Project: Tommy Smith Elementary School Renovation

ADDENDUM NO. 01

To Plans and Specifications for: Tommy Smith Elementary School Renovations Panama City, Florida Architect Project No: 22045D

Elkay Lustertone Classic Stainless Steel 22" x 17" x 7-5/8" 2-Hole Single Drop-in Classroom Sink + Faucet/Bubbler Kit Model(s) DRKR2217LC

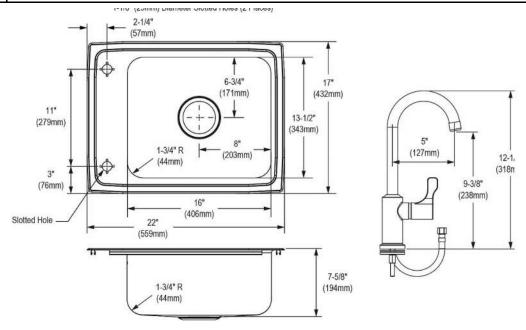
- A. The bidders shall include the following quantity in the bid price to remove and replace existing sinks, faucets, and bubblers.
 - a) Quantity of Locations: 30 at new millwork
- B. See product specs attached to this Addendum #1 for new SINGLE-BOWL sink assemblies that include new sink, new bubbler, new drain, and new faucet.
 - a) Attached product specs consists of (2) total pages.
- C. The bidder shall also include the following in the bid price:
 - a) Remove and replace existing sink, faucet, drain, and bubbler if present. Remove and replace P-trap, tailpiece, and associated waste piping back to wall. Remove and replace hot and cold water supply piping back to existing stops. Remove and replace any non-functional hot or cold water supply stops. All new piping shall be the same size and material as existing.

CLASSROOM
DOUBLE BOWL SINK - ASSEMBLY

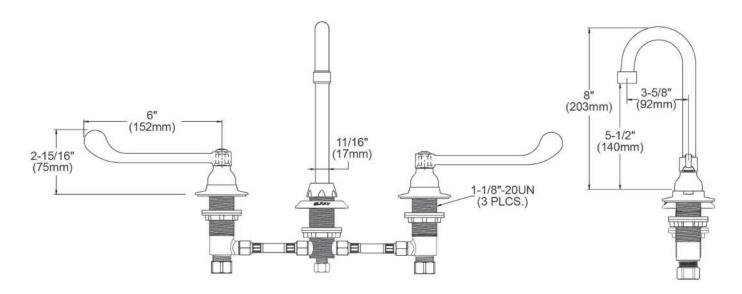
- A. The bidders shall include the following quantity in the bid price to remove and replace existing sinks, faucets, and bubblers.
 - a) Quantity of Locations: 12 at new millwork
 - i. Provide at classrooms and Clinic 1-149
- B. See product specs attached to this Addendum #1 for new DOUBLE-BOWL sink assemblies that include new sink, new drain, and new faucet.
 - a) Attached product specs consists of (4) total pages.
- C. The bidder shall also include the following in the bid price:
 - a) Remove and replace existing sink, faucet, and drain.. Remove and replace P-trap, tailpiece, and associated waste piping back to wall. Remove and replace hot and cold water supply piping back to existing stops. Remove and replace any non-functional hot or cold water supply stops. All new piping shall be the same size and material as existing.

"FLASHING INFILL" BETWEEN GUTTERS AND METAL WALL PANELS

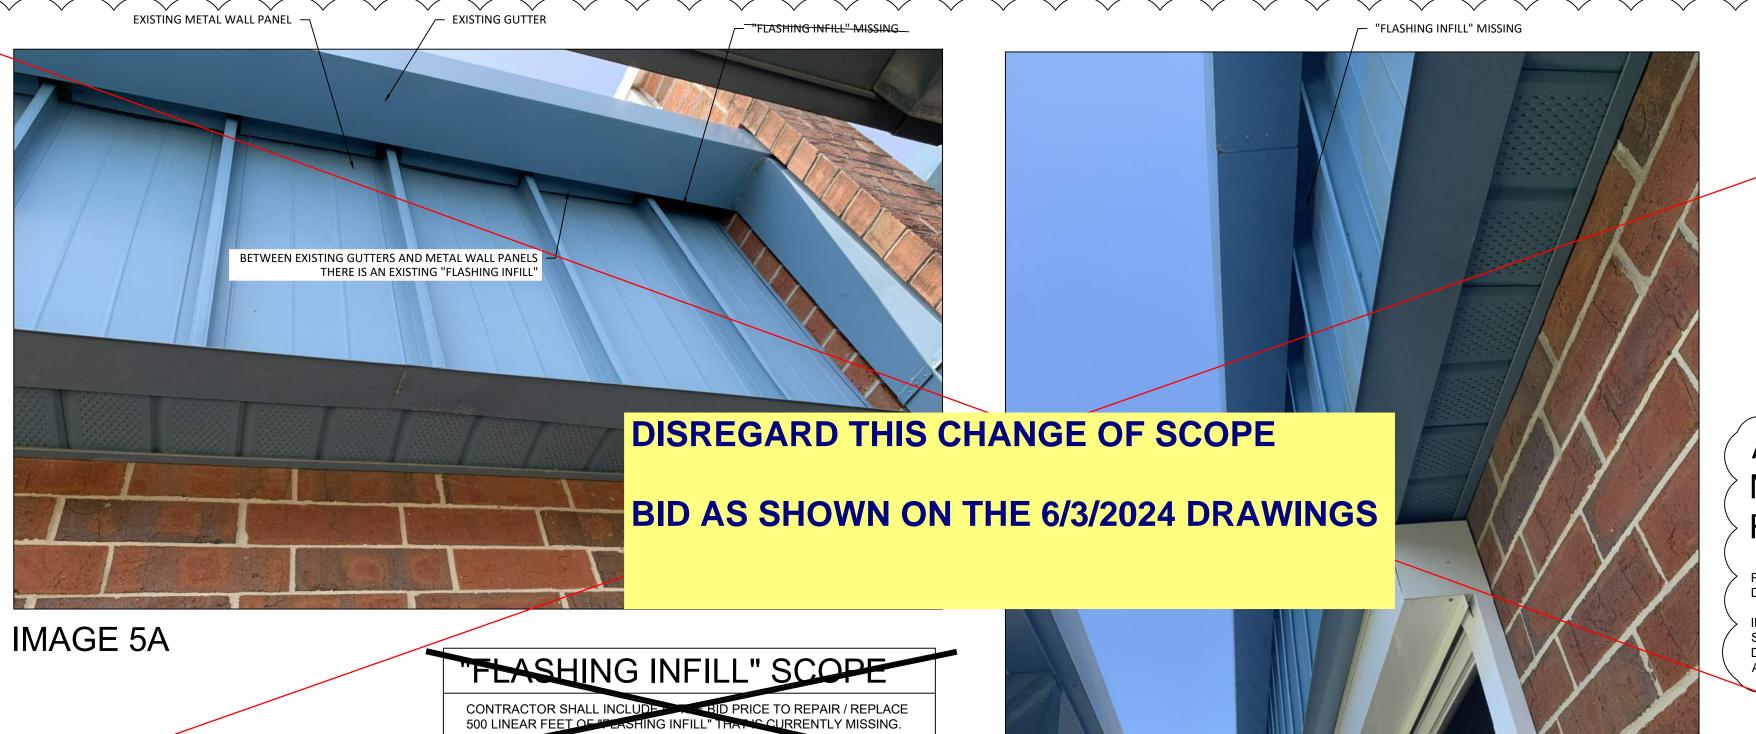
- D. Delete tack strips
- 2. Refer to Drawing A121 Roof Plan: Delete sheet and replace with revised sheet attached to this Addendum #1. Revisions include deleting the 'flashing infill' scope and replacing it with metal wall panel renovation scope.

IN LIEU OF THE 'FLASHING INFILL' WORK THE CONTRACTOR SHALL RENOVATE THE EXISTING METAL WALL PANELS AS DESCRIBED ON NEW DRAWING SHEET A122 ATTACHED TO **VOLUME 1**

KINDERGARTEN MILLWORK RENOVATIONS SHEET NUMBER

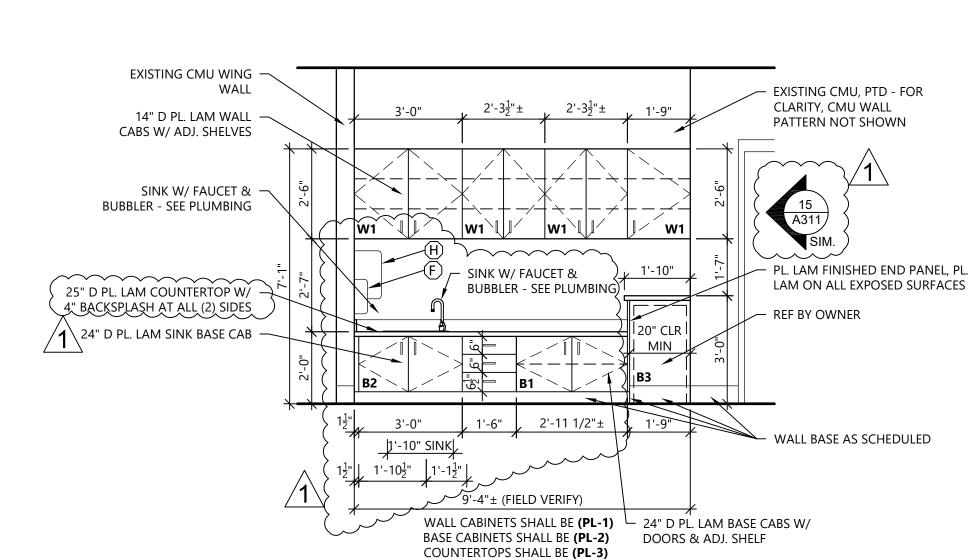
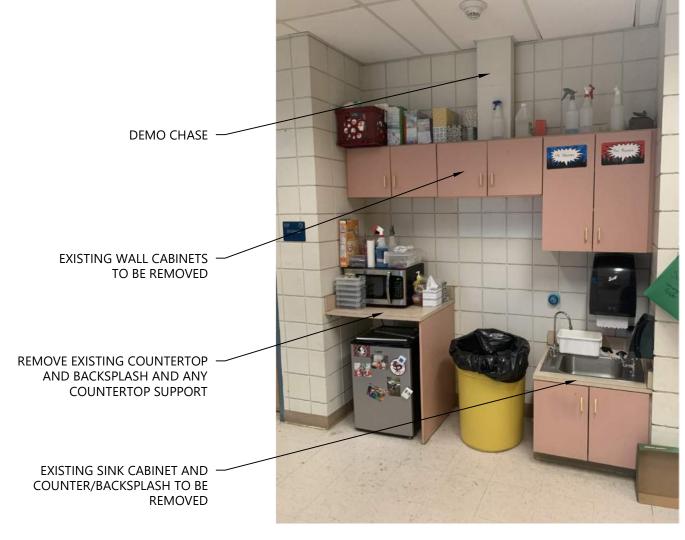
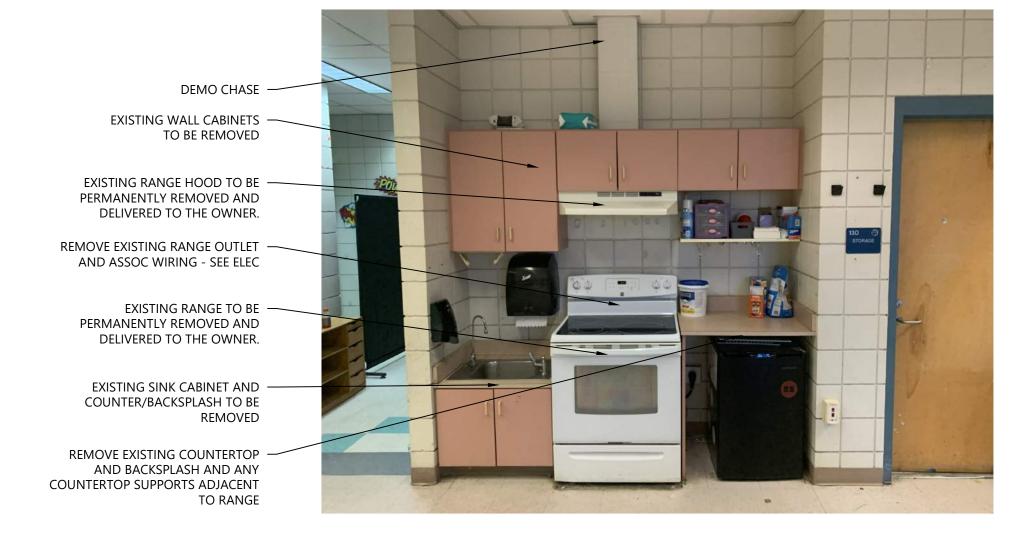
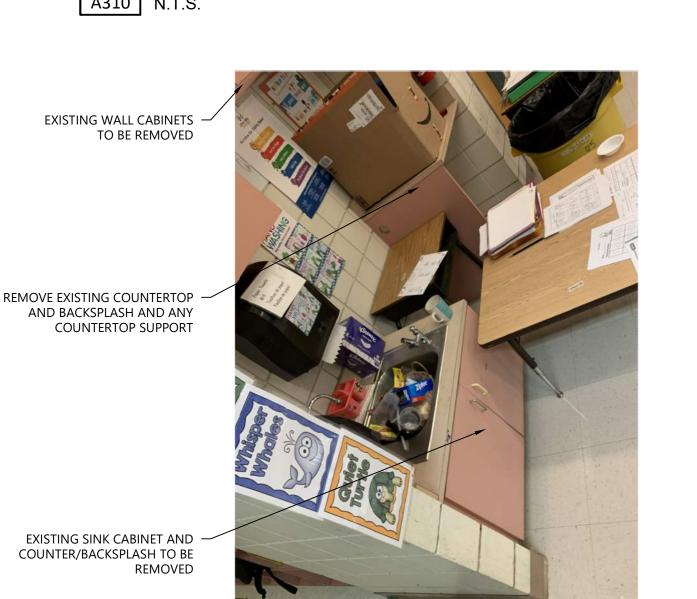
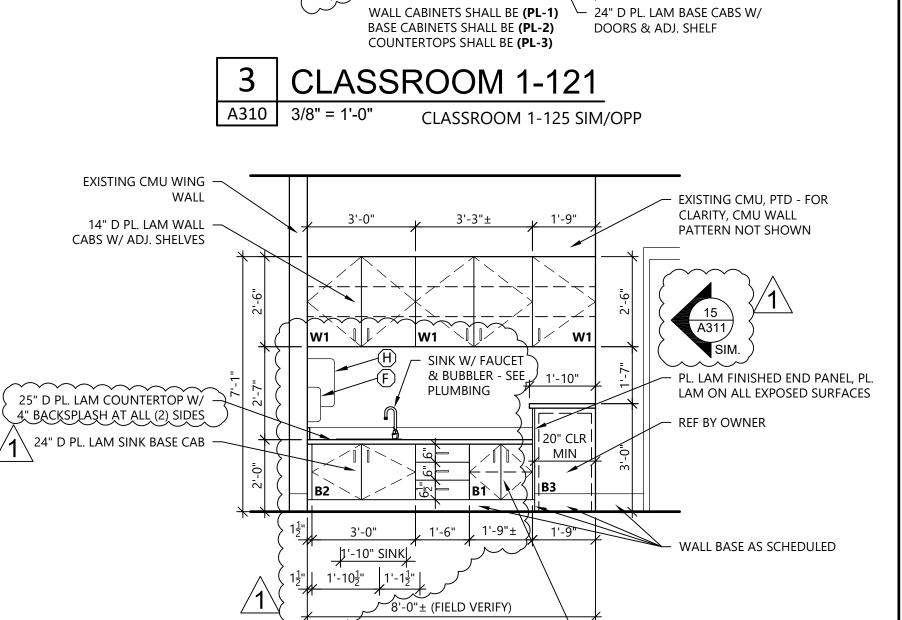
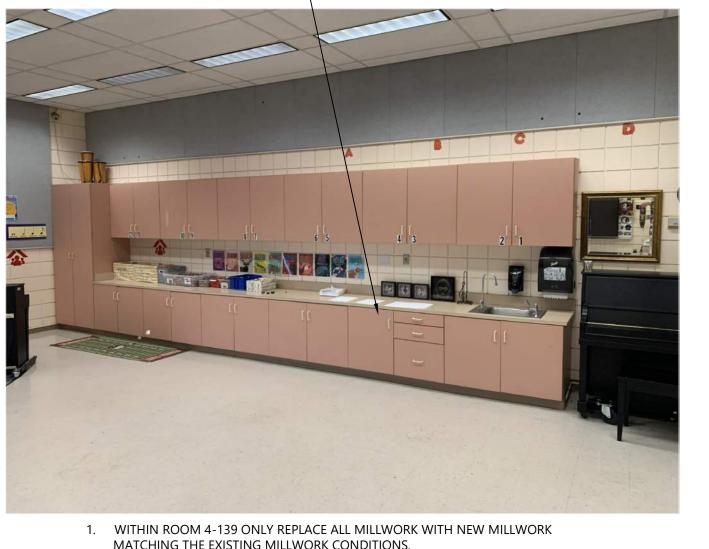
- A. Add this new sheet to the drawing index.
- **4. Refer to Drawing A310 Kindergarten Millwork Renovations:** Delete sheet and replace with revised sheet attached to this Addendum #1. Revisions include revising millwork design and clarifying the installation of new soap dispensers and paper towel dispensers.

10 | SPECIALTY CLASSROOMS - MILLWORK A311 3/8" = 1'-0"

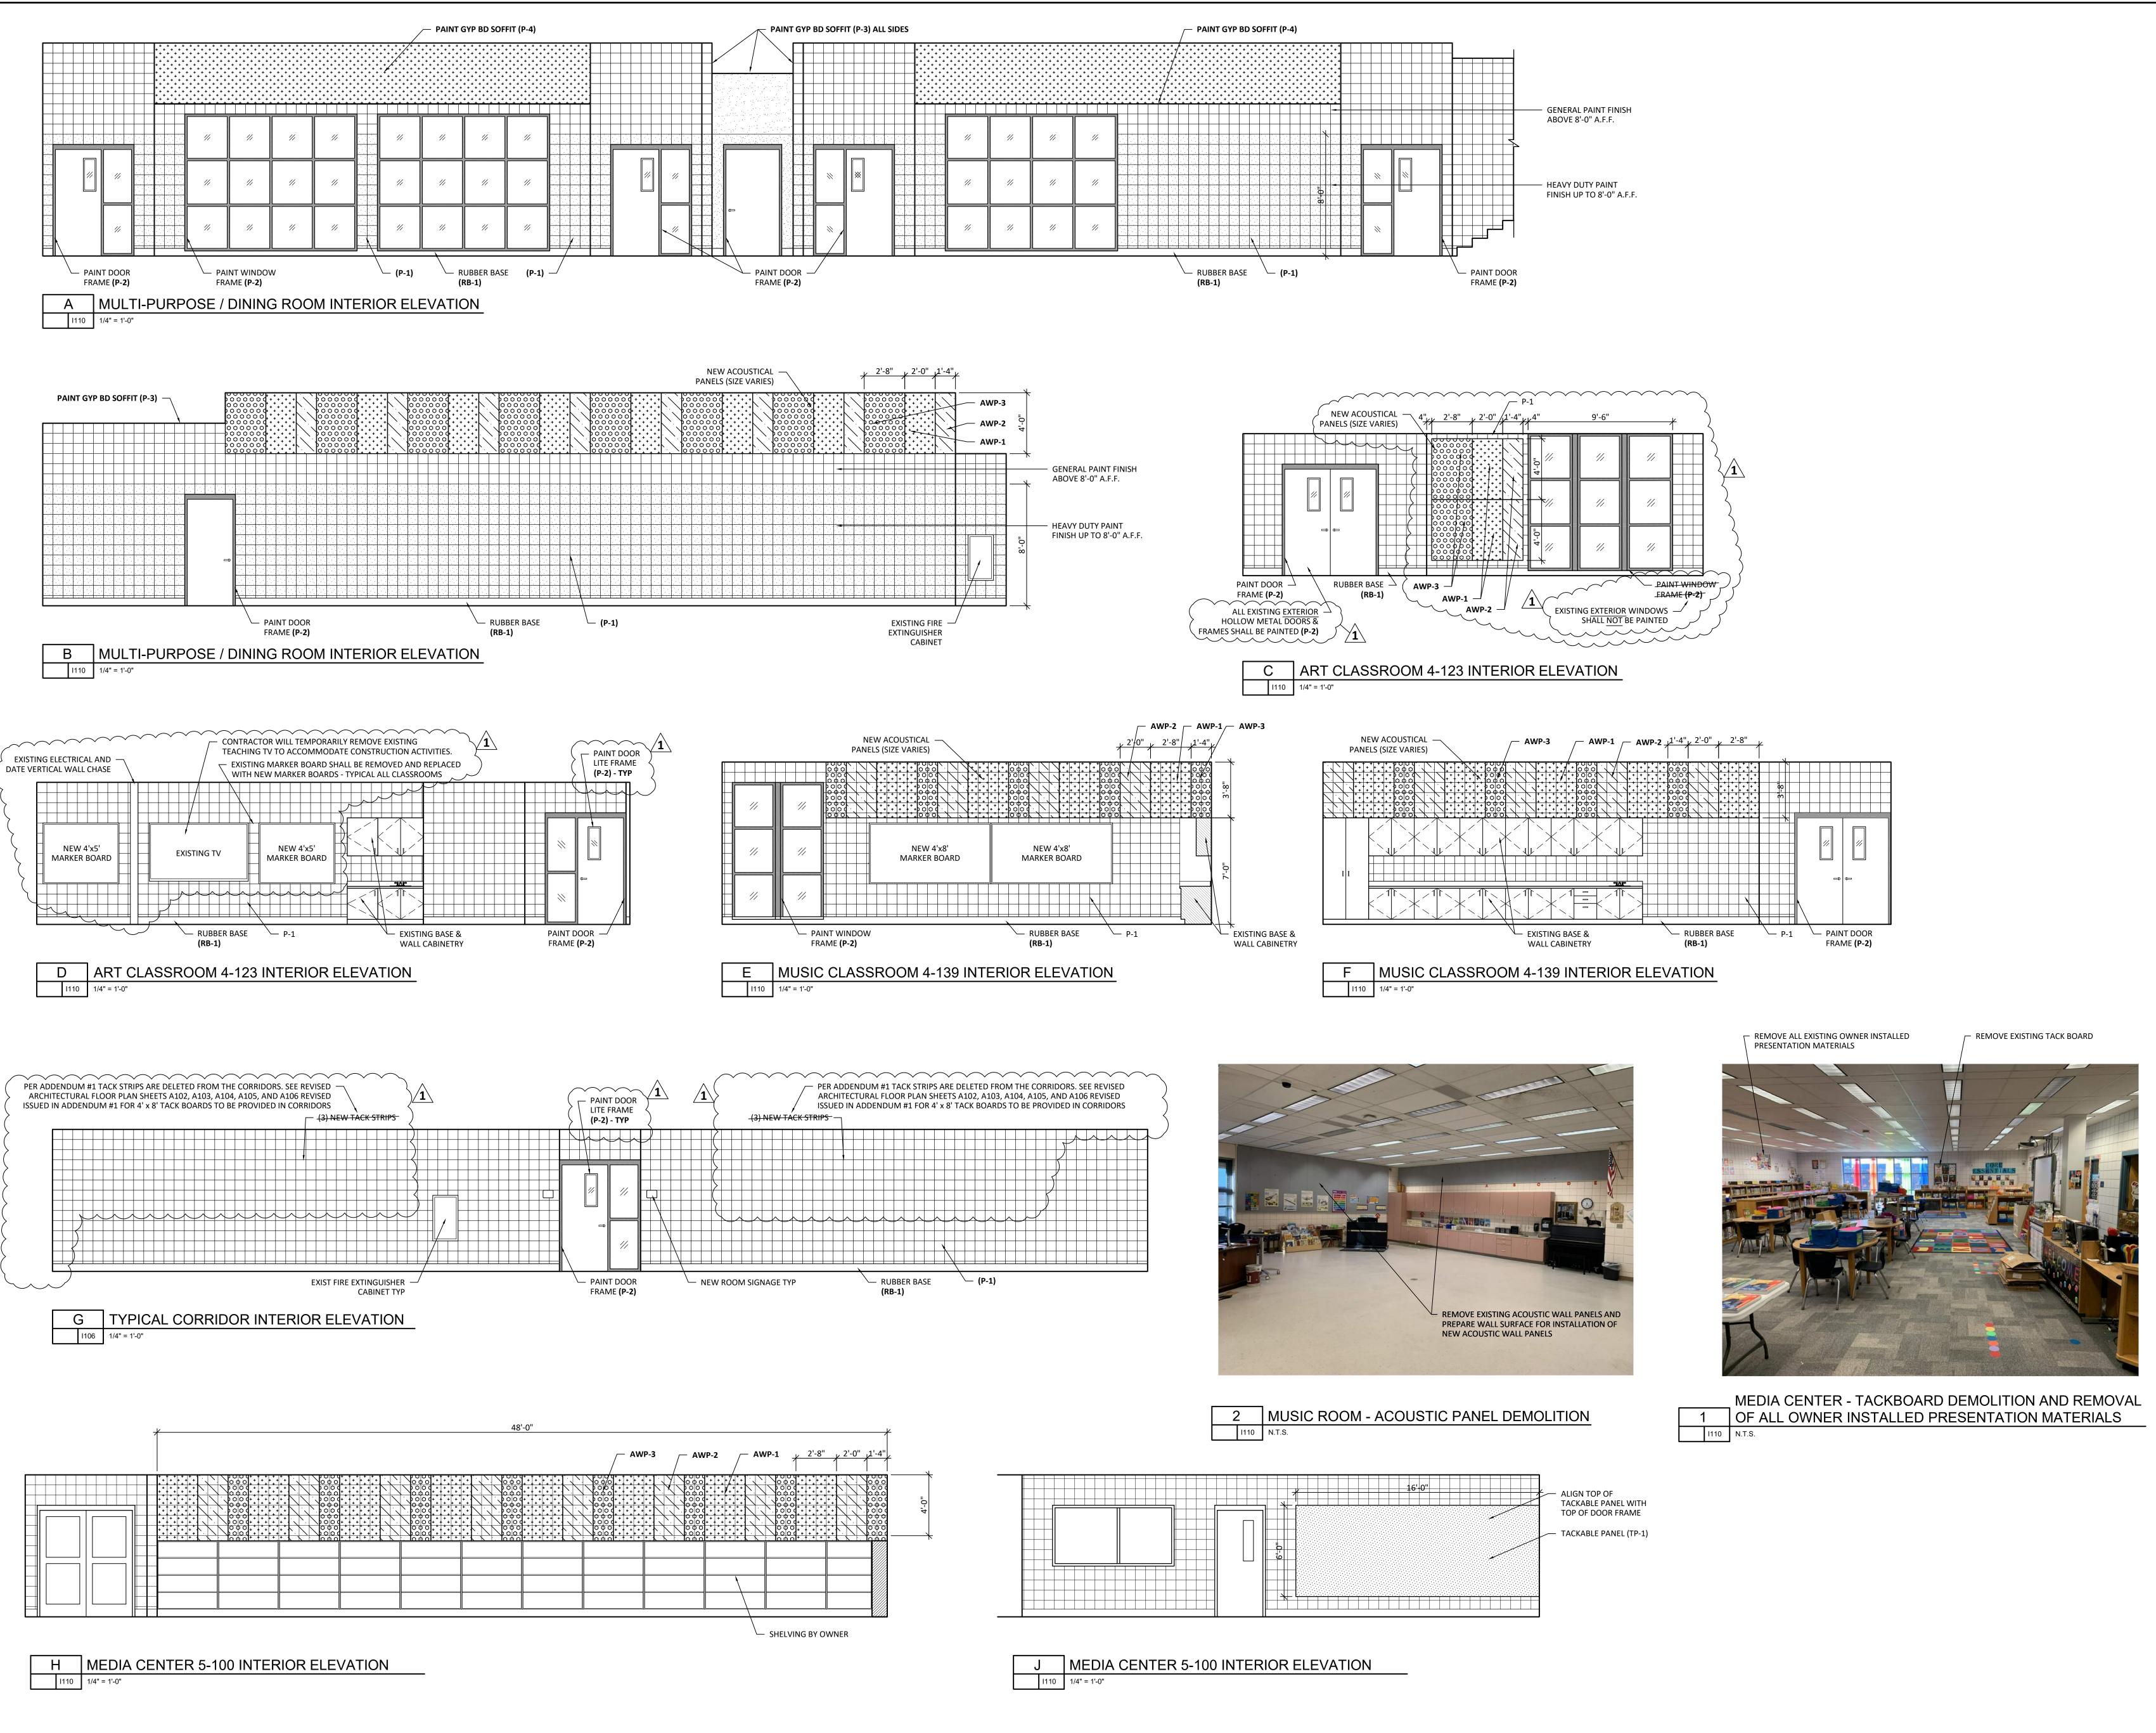
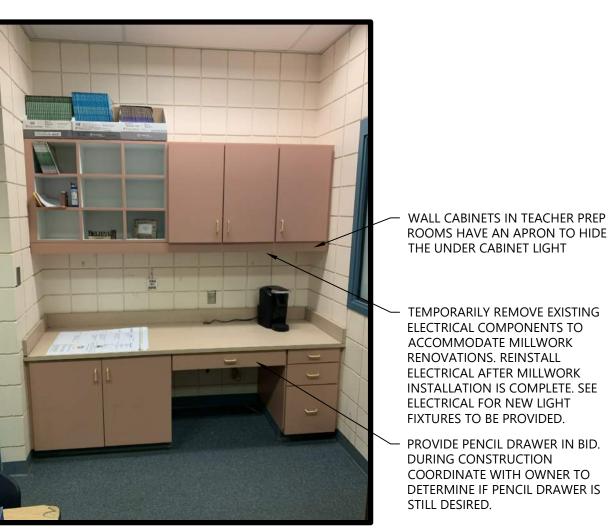
- 5. Refer to Drawing A31 Classroom Millwork Renovations: Delete sheet and replace with revised sheet attached to this Addendum #1. Revisions include revising millwork design and clarifying the installation of new soap dispensers and paper towel dispensers.
